# MASONRY RESTORATION – BLANDEN MUSEUM

City of Fort Dodge

July 7, 2021	Bid Documents Released
July 22, 2021	Pre-Bid Meeting (not mandatory) at 3pm
<b>July 23, 2021</b>	<b>UPDATE PLANS SENT AND POSTED</b>
August 4, 2021	Bids Due to City Hall, 11:00 am CST
August 9, 2021	Council Meeting for Approval (if needed)
August 10, 2021	Begin project
October 29, 2021	Project Completion

## SCOPE OF WORK, WATER TABLE:

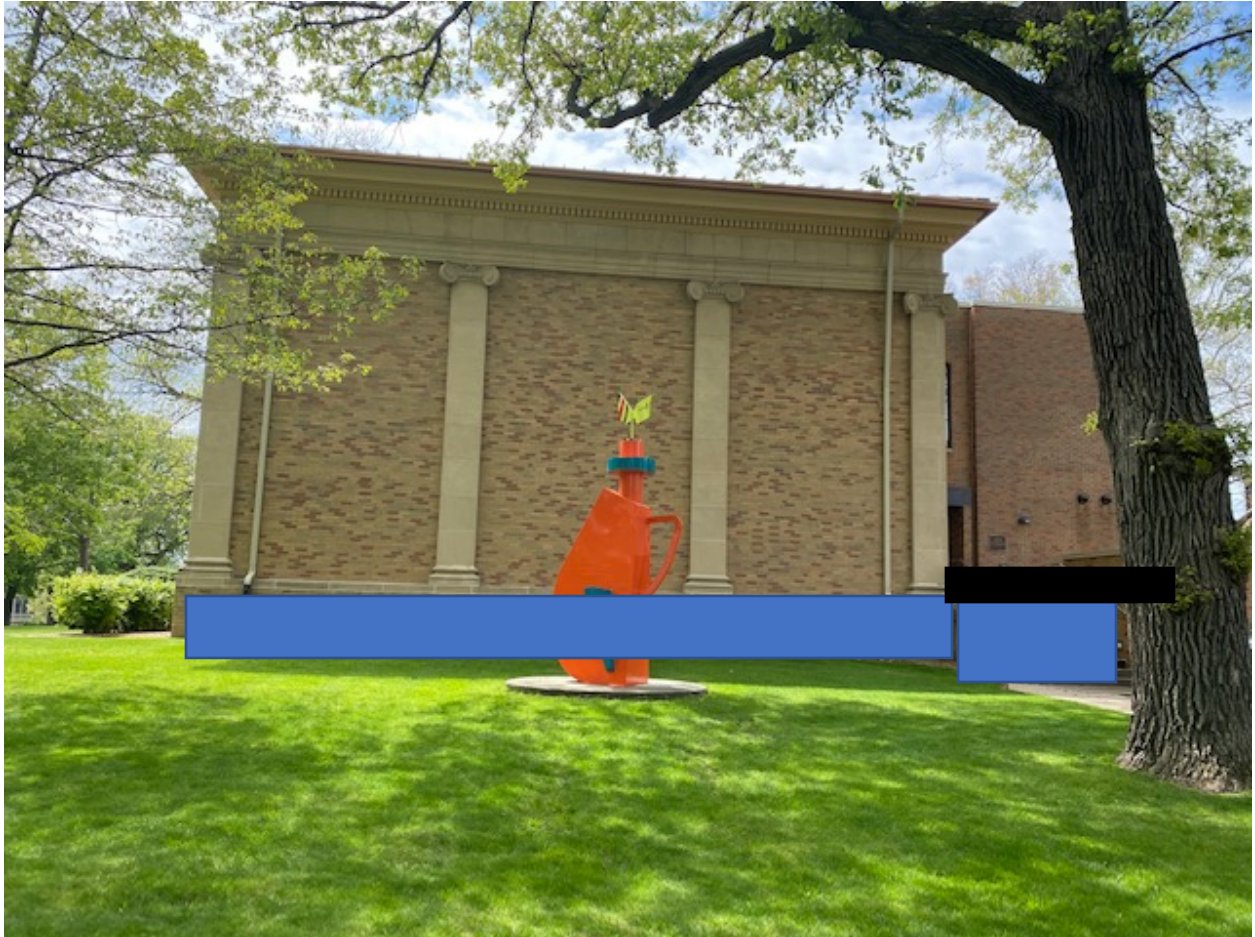
- **UPDATE:** Remove, grind to 1" depth, point back, rake joint, install backer rod, re-caulk water table head joints and top & bottom bed joints
